**ADDENDUM no. 2 to the
FINAL ENVIRONMENTAL IMPACT REPORT/ENVIRONMENTAL ASSESSMENT for
the
U.S. HIGHWAY 50/EL DORADO HILLS BOULEVARD-LATROBE ROAD
INTERCHANGE PROJECT**

AUGUST 2008

Project Title: U.S. Highway 50/El Dorado Hills Boulevard-Latrobe Road Interchange
EIR/EIS ADDENDUM no.2

FIGURE H

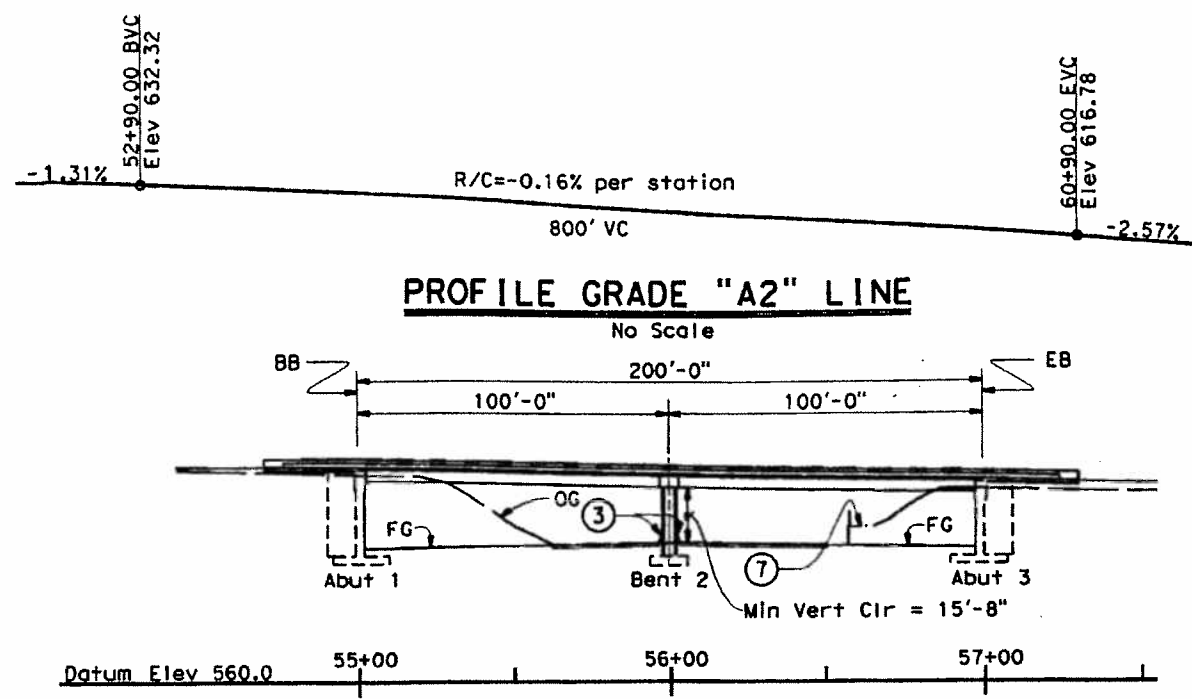
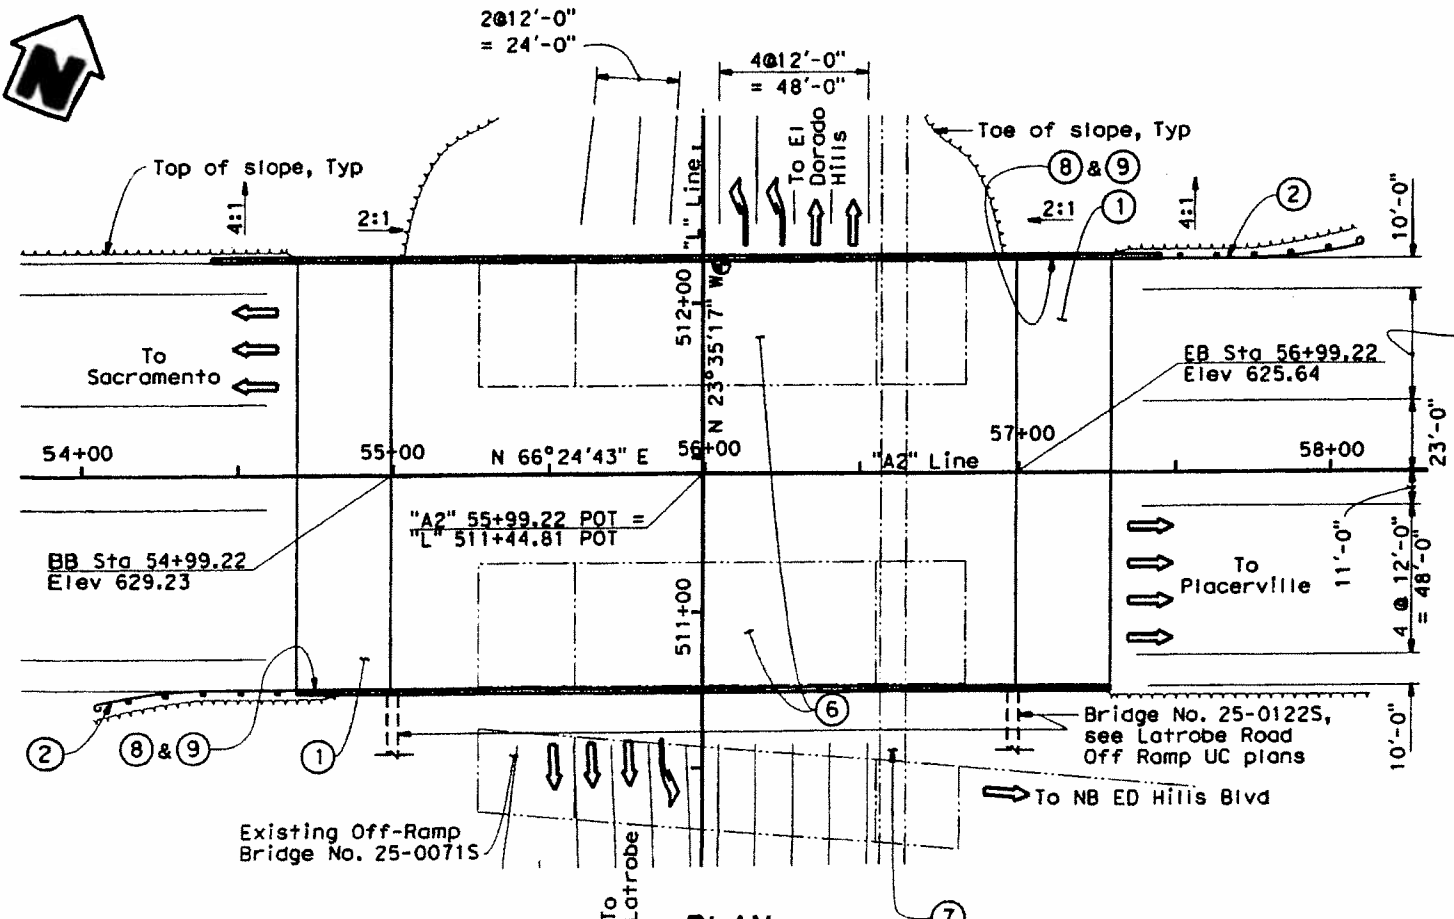
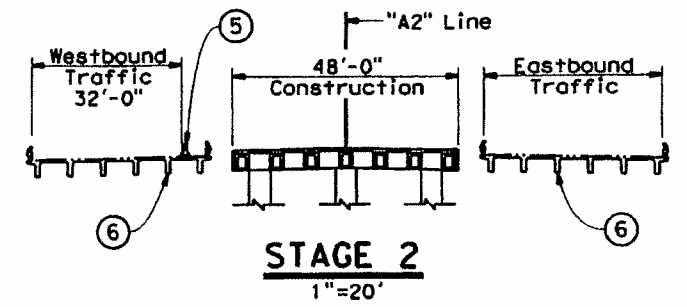
The original type of bridge structure (4 span, cast in place concrete box girders with open end abutment) could not be economically built due to the requirement to maintain a minimum vertical falsework clearance for traffic under the bridge during construction. The proposed replacement bridges are 2 span precast concrete box girders with closed end abutments. The proposed mainline bridge is depicted in Figure H and the EB off-ramp bridge is depicted in Figure I. The bridge length is shorter partially due to hauling limitation for the precast girders. It is also shorter and narrower than the bridge proposed in the EIR/EA because the larger size is not needed and it reduces costs.

The original design dimensions of the mainline bridge in the June 2000 Project Study Report/Project Report (PSR/PR) were 241.5 feet long and 163.67 feet wide. The current proposal would replace the existing mainline bridge with a structure that is 200 feet long and 141 feet wide. The proposed EB off-ramp replacement bridge is shorter for the same reasons but the width (39 feet) remains the same as the bridge in the PSR/PR. The proposed EB off-ramp bridge is 200 feet long vs. 241.5 feet long in the PSR/PR. All replacement bridges are within the same footprint area.

Figure J
1 of 2
L-3

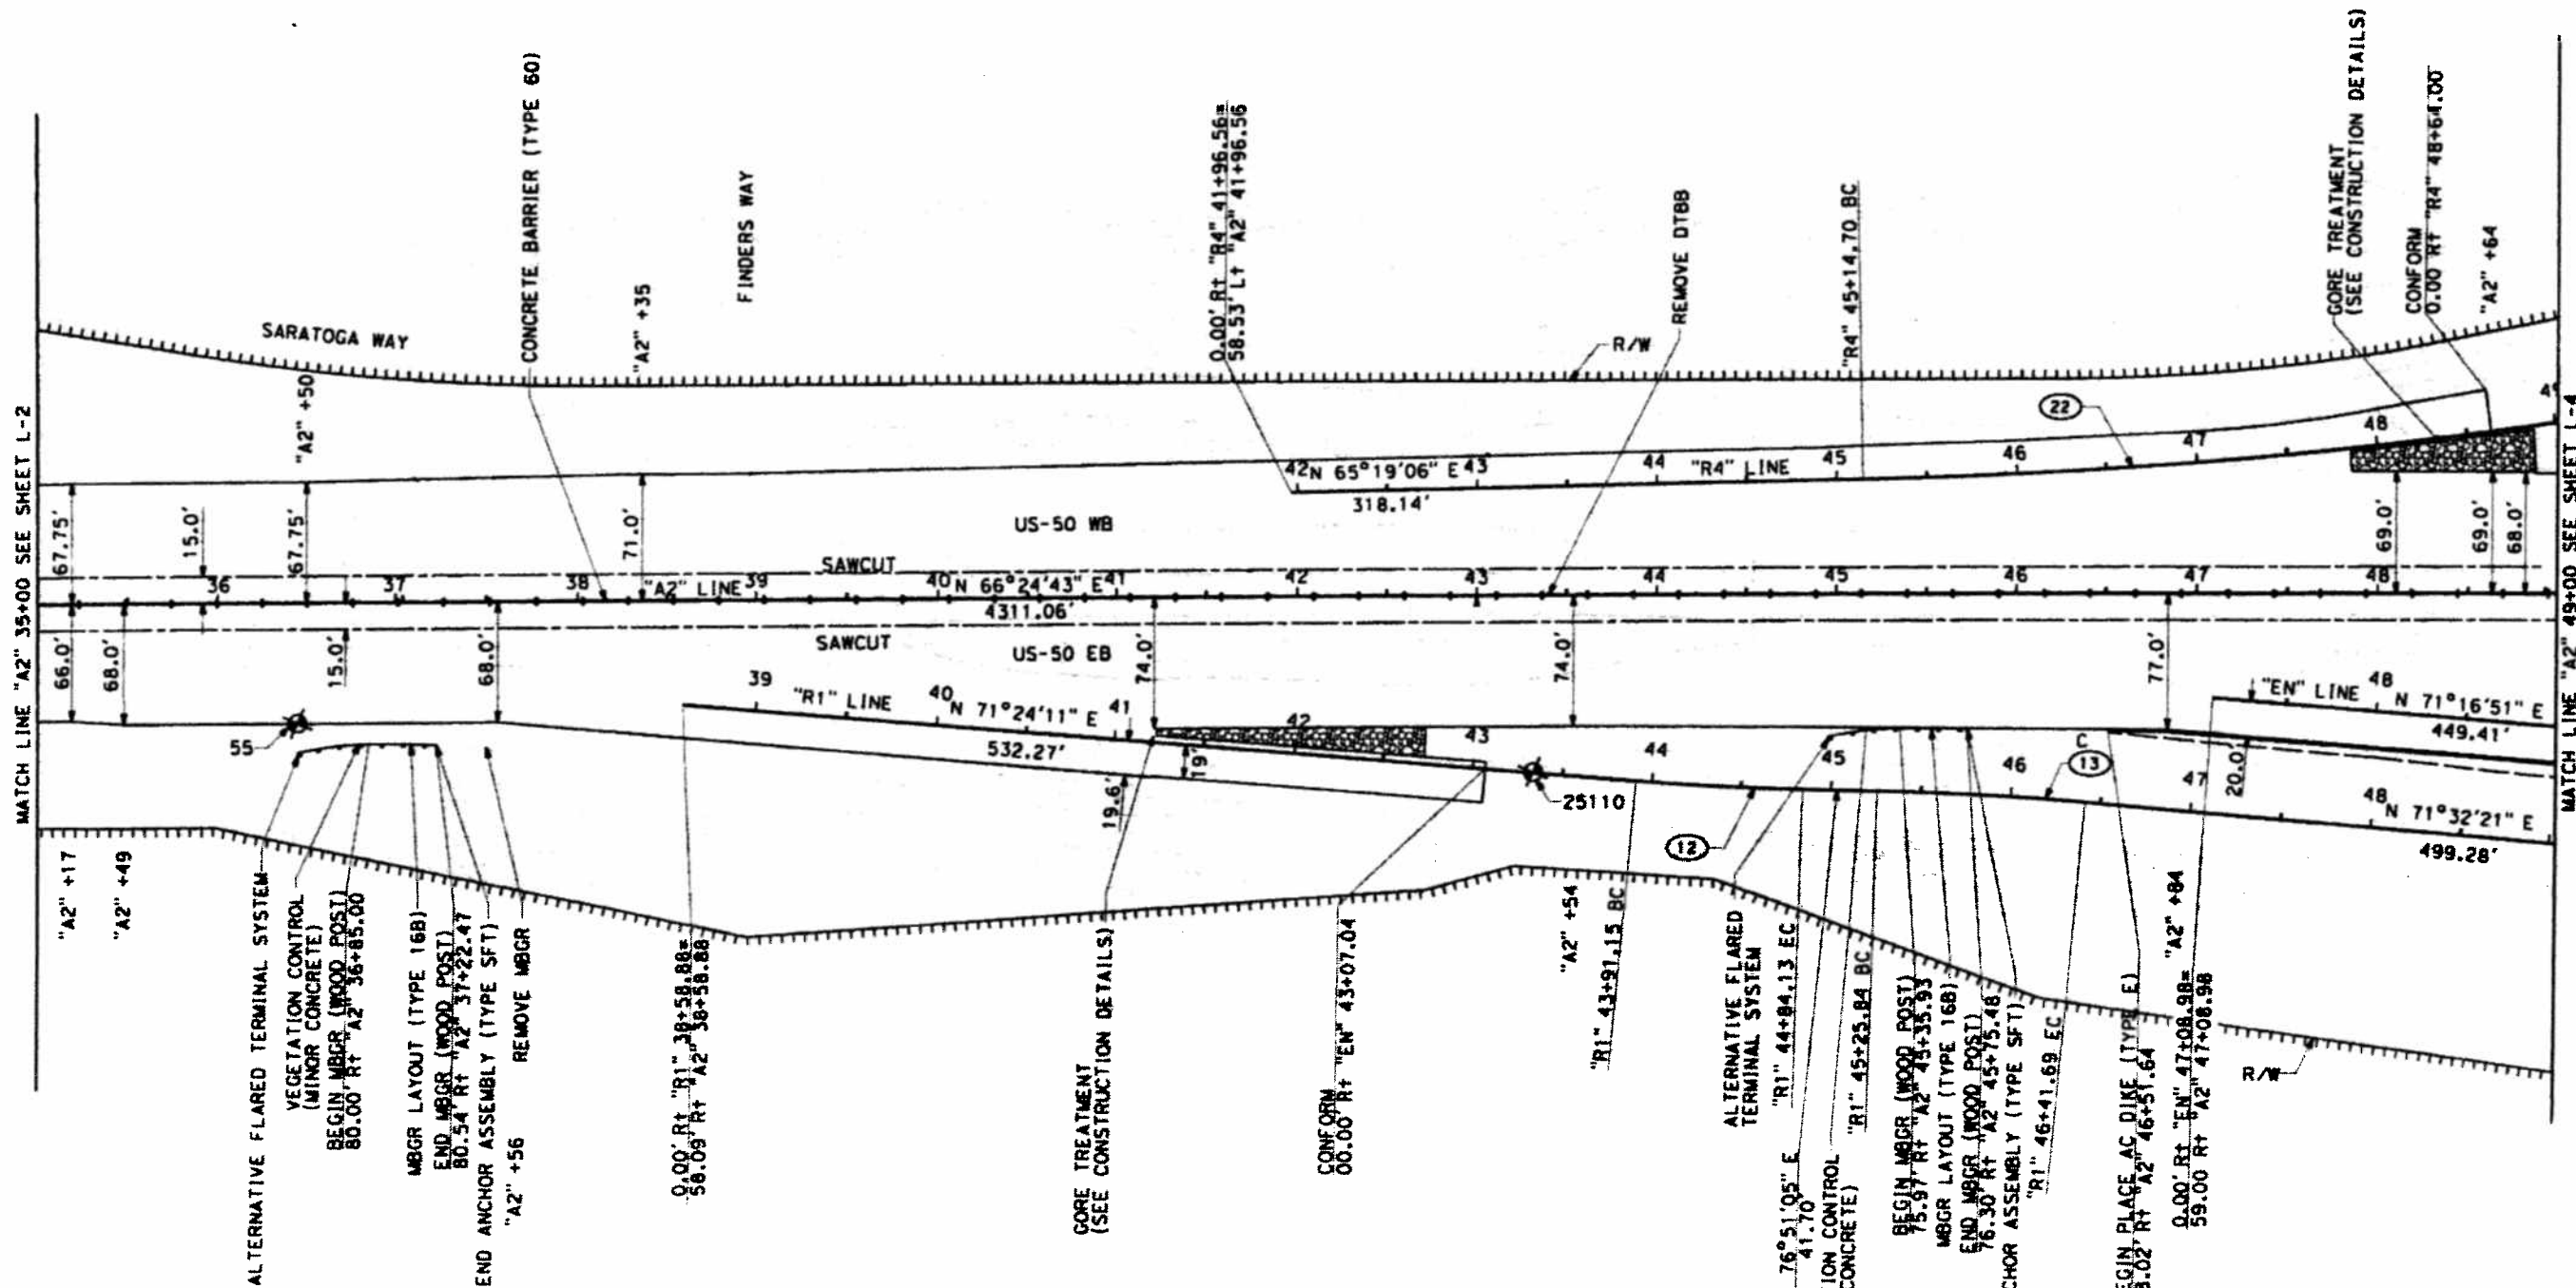
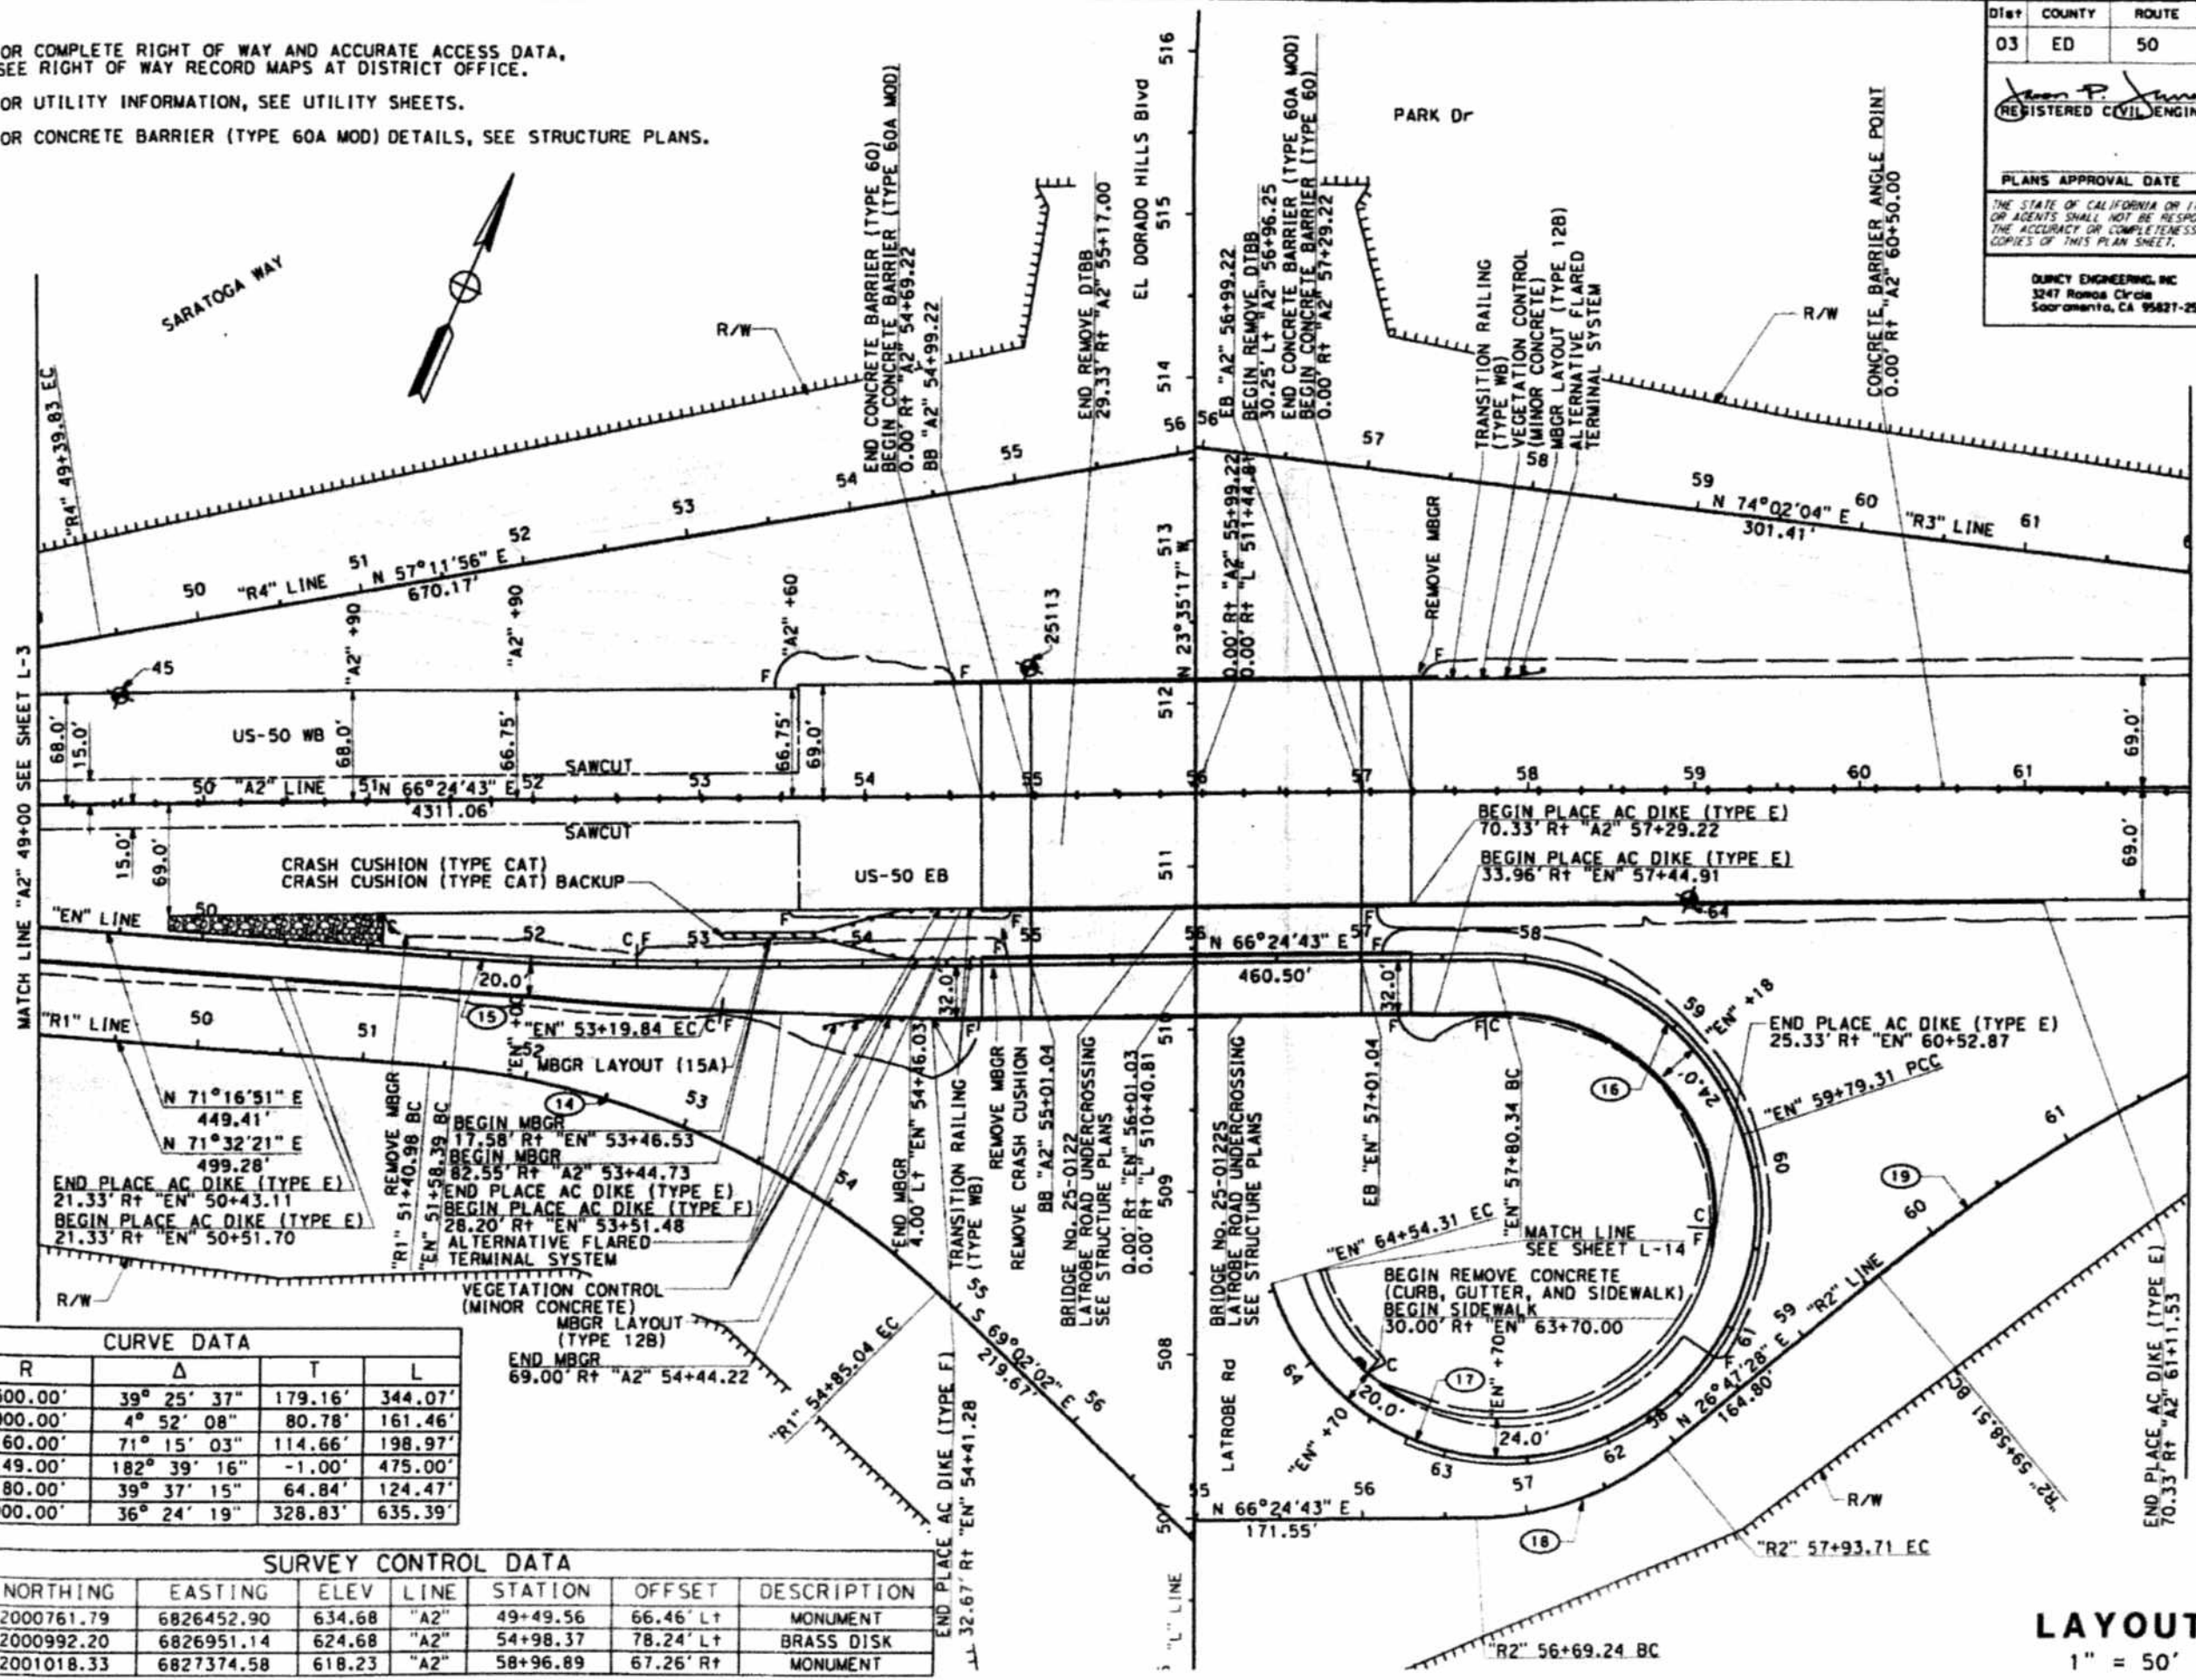
In the proposed project the alignment of the EB off-ramp will be modified from the ultimate configuration in the EIR/EA, shown in Figure B, to an interim condition as shown in Figure J in order to align the ramp with the replacement bridge. This interim phase does not include lengthening and widening (to 2 lanes) the eastbound to southbound off-ramp due to funding limitations. The ramp will remain a single lane instead of 2 lanes and the gore point will occur between the existing and ultimate gore points for the interim condition. This results in a shorter, narrower ramp for the interim condition. The ramp will remain a dedicated ramp for northbound El Dorado Hills Blvd traffic for the interim condition. The ultimate EB ramp alignment will be constructed in Phase 2B per the EIR/EA, as shown in Figure B.
